MIL-M-28787/73A
AMENDMENT 1
31 December 1992

MILITARY SPECIFICATION

MODULES, STANDARD ELECTRONIC

RECEIVER, INTERFACE, DIGITAL, KEY CODE JHK

FIGURE 23. Power supply filter capacitance and input capacitance test circuit for tables XXIII and XXIV.

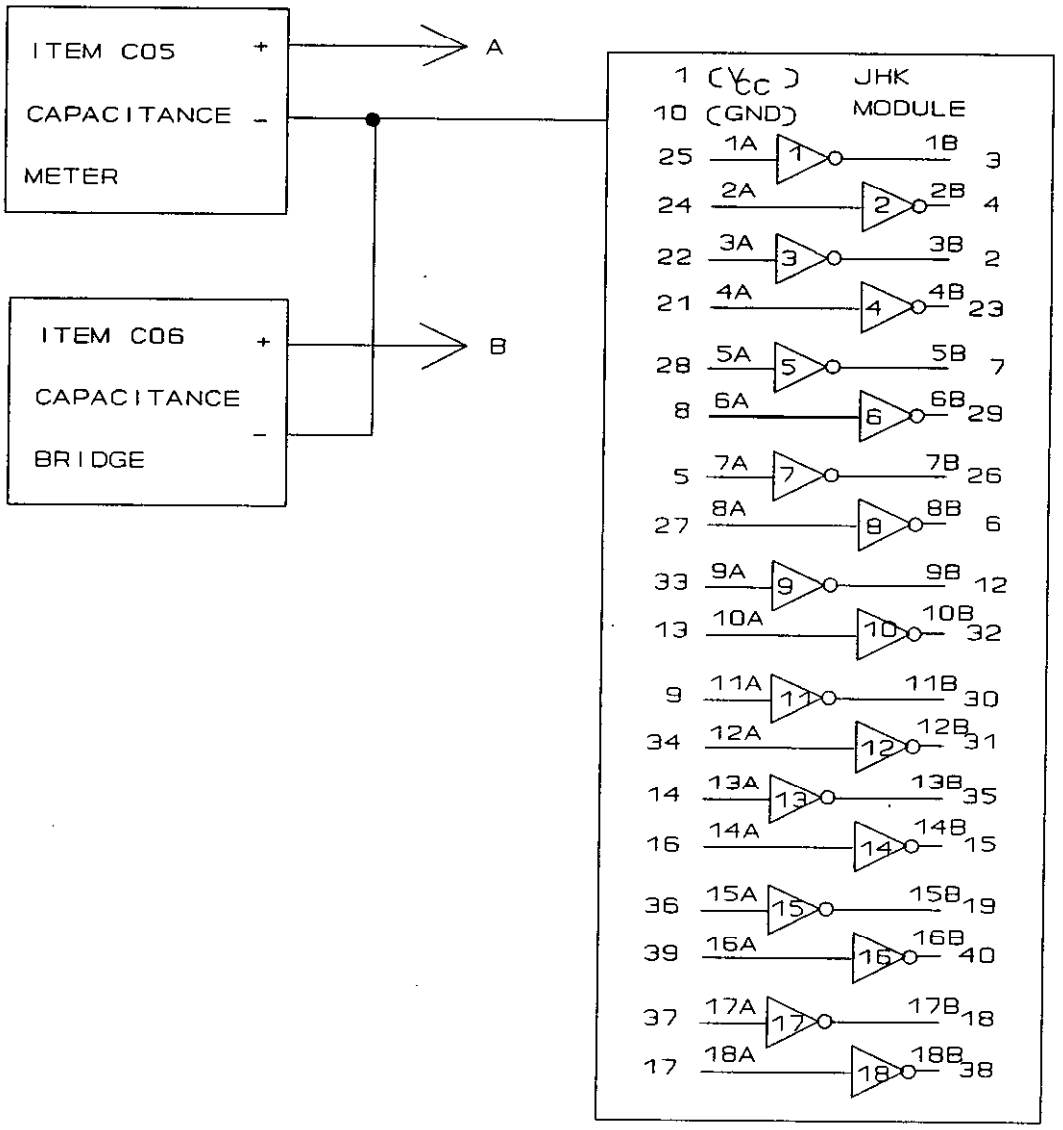
FIGURE 23: Delete and substitute new figure 23 as printed on page 3 of this amendment.

1. Null out the effects of the test leads prior to connecting the module.
2. Do not attach test connector or wires to any of the module pins other than pin 10 and the pin under test. Stray capacitance added to other pins may affect the readings.
3. Capacitance bridge (C06) setup: Frequency = 1 kHz.
   V_{pk} = 0.3 V maximum.
